EGG-EA-5475

ADEQUACY OF STATION ELECTRIC DISTRIBUTION SYSTEM
VOLTAGES, OYSTER CREEK NUCLEAR POWER STATION,
DOCKET NO. 50-219

Technical Evaluation Report

Figure 1. Oyster Creek Nuclear Power Station electrical distribution system single-line diagram.

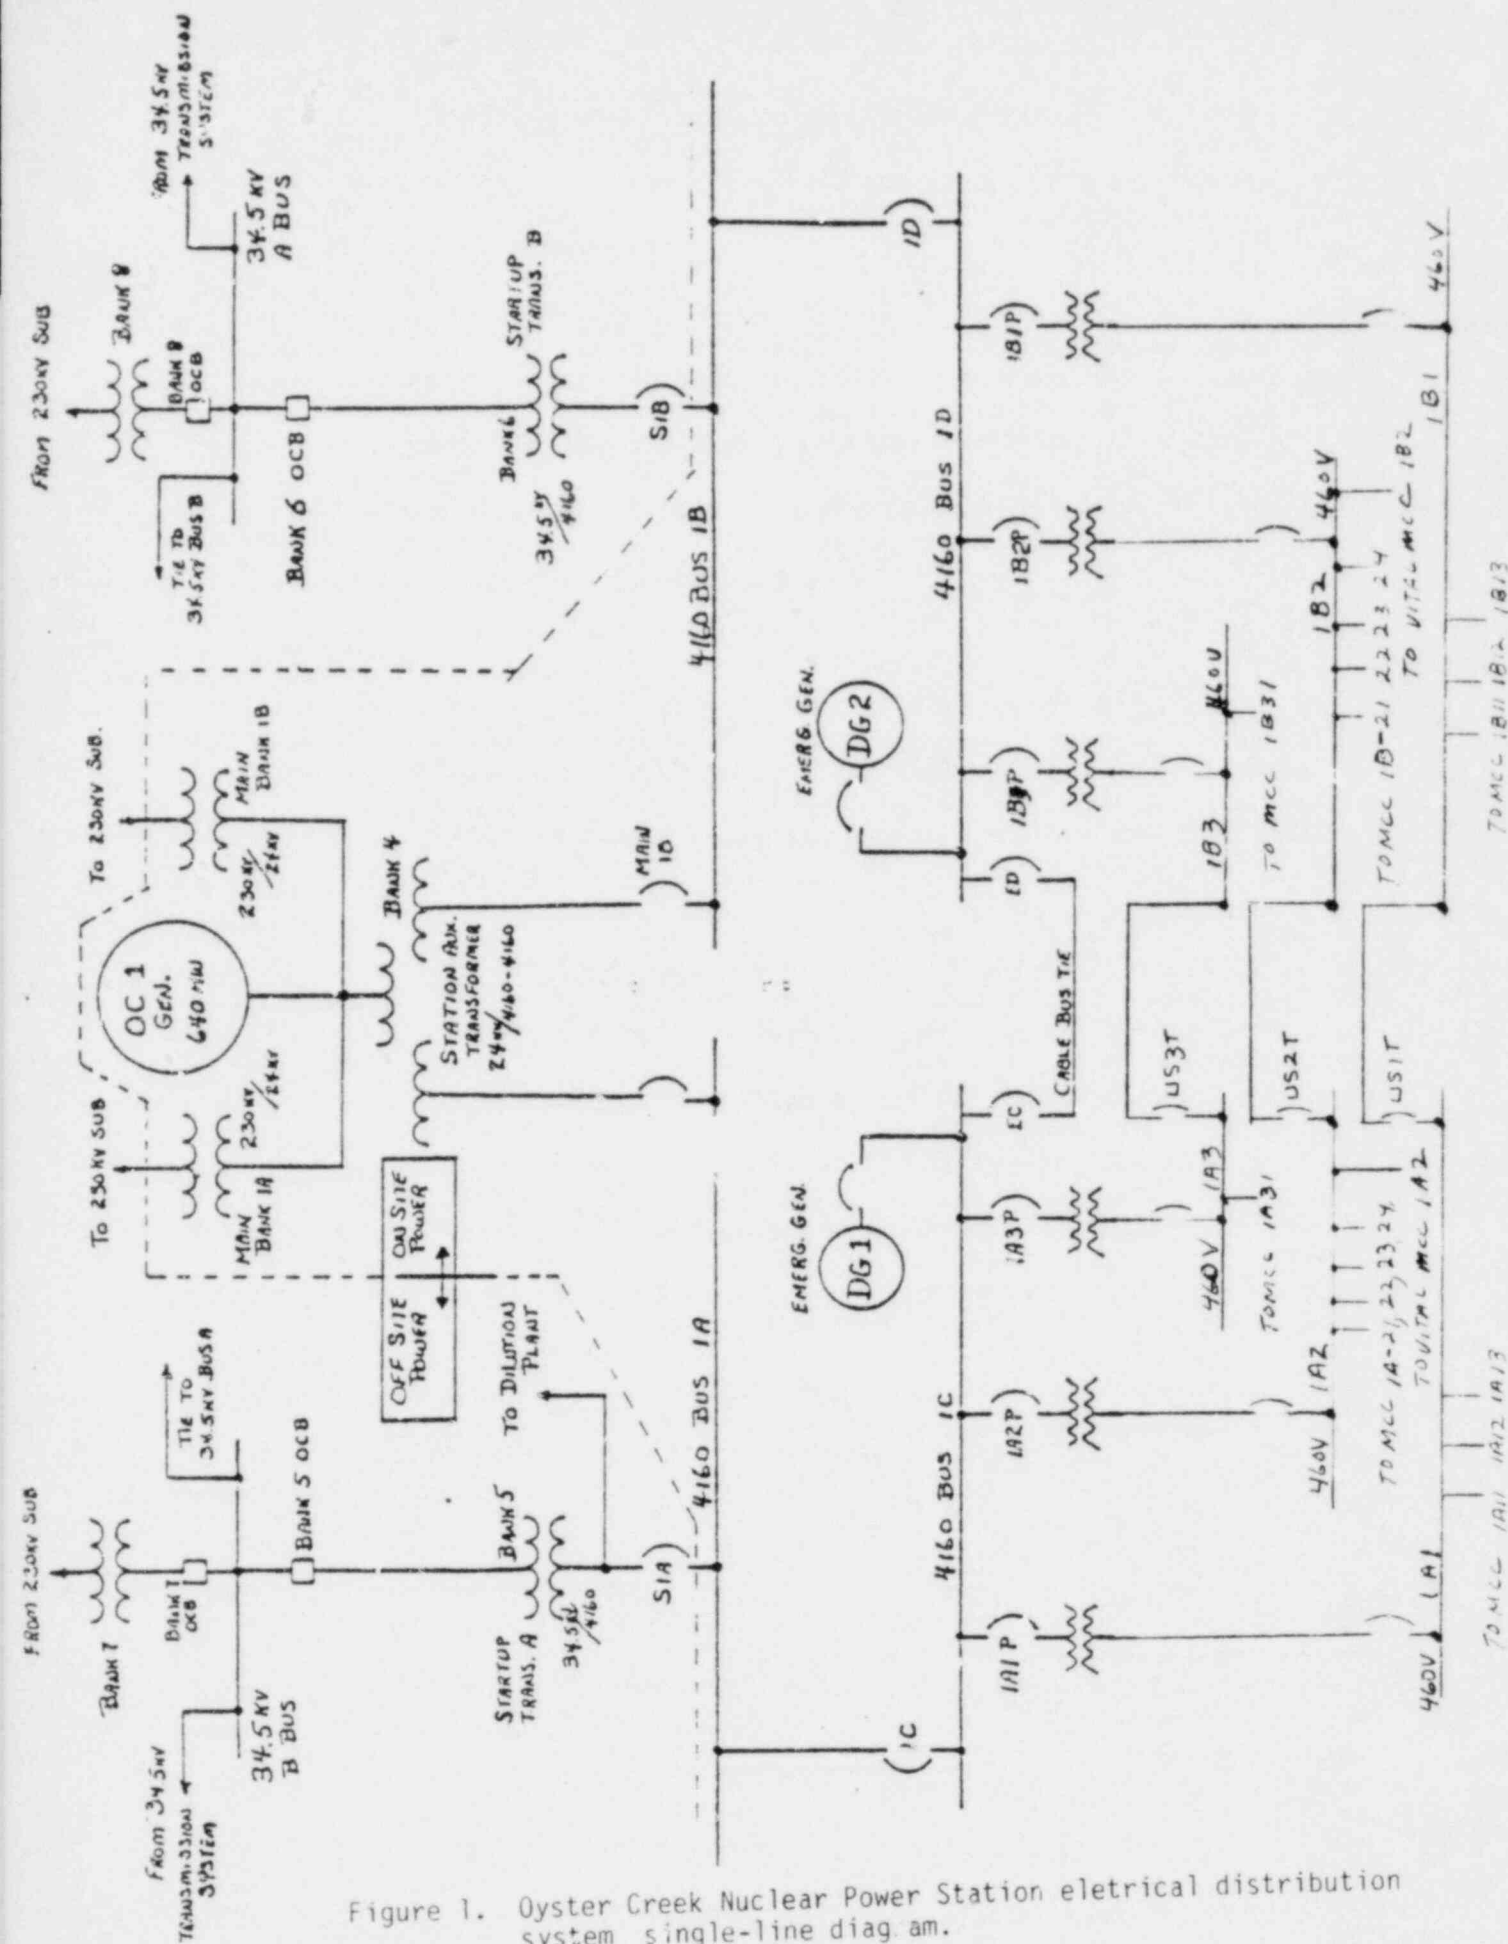
This position is not satisfied without voltage regulation as certain 460V motor starters and the 480V motors would be required to operate a voltage below the minimum ratings (Table 1).

This position is not satisfied without voltage regulation as some of the 440V motors would have voltage in excess of maximum rating. Maximum voltages on equipment with 115V nominal rating not provided.

This position is not satisfied as the second level undervoltage relays could operate if the grid is at or slightly above its minimum analyzed value (Table 2).

As a result of their original analysis JCP&L has installed voltage regulators on the 34.5kV grid, which maintain the 4160V bus between 4100V and 4210V for extremes of normal offsite grid voltages. These voltage regulators will maintain all safety related equipment within their operating limits and prevent spurious separation of class 1E buses from the offsite power sources. However, credit for these regulators is dependent upon inclusion of limiting condition of operation requirements in the plant technical specifications.
